## **Attachment 10**

This attachment includes photos from several construction sites inspected on April 9-10, 2014. Sites include private development, capital improvement projects (CIPs), including two linear undergrounding projects (LUPs).

Photos from Audit Field Days  
Location: Bankers Hill (LUP Job 945)

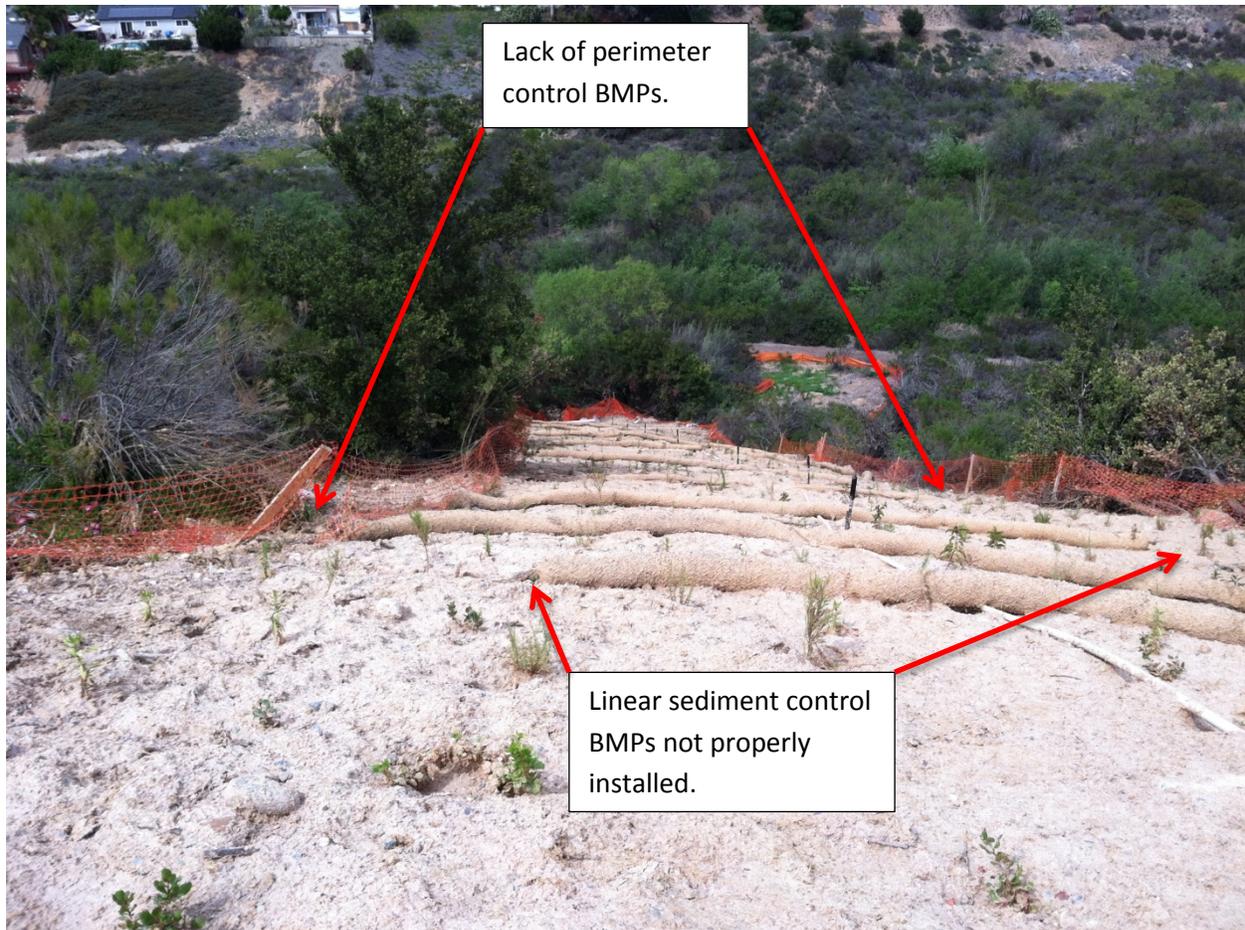
Inadequate Storm Drain  
Inlet Protection

Rusty pipe should be contained and not in contact with ground.

In the event of rain, City must have BMP plan for the excavated soil.

Storm drain inlet BMPs need maintenance

Stockpile not properly contained and heavy equipment can disperse material into the street and offsite.
